Access Compliance Report

Public Rights-of-Way

(Curb Ramps)

| Intersection ID: 53235 | Main Street: EVERGREEN_DR | Cross Street: DOLLY_MADISON_RD | Location: NE |

| ADA ID: AD29C89B376B | Ramp Type: Perp | Initial Pass/Fail: Fail | Overall Compliance: No |

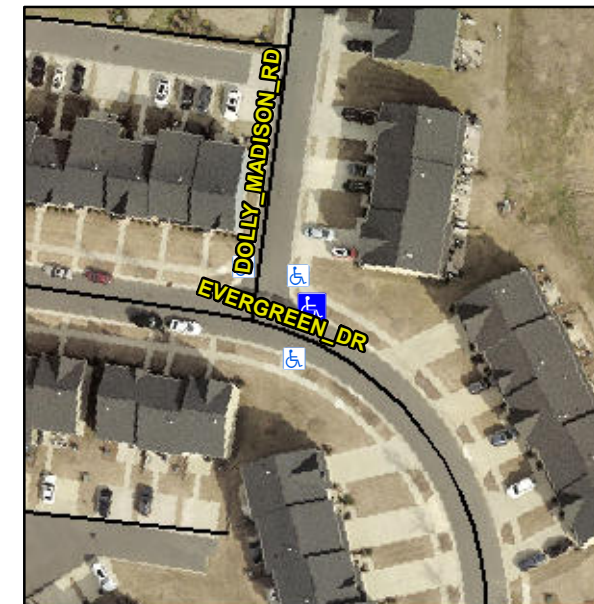
Remove & Replace Entire Ramp.

R304.5.1, R304.2.2

| Compliance | Description | Data | Compliance | Description | Data |
|------------|-----------------------|------|------------|-----------------------------|------|
| N/A | Ramp Length (in) | 66.0 | No | Ramp Slope (%) | 8.5 |
| No | Ramp Width (in) | 47.5 | Yes | Ramp XSlope (%) | 2.2 |
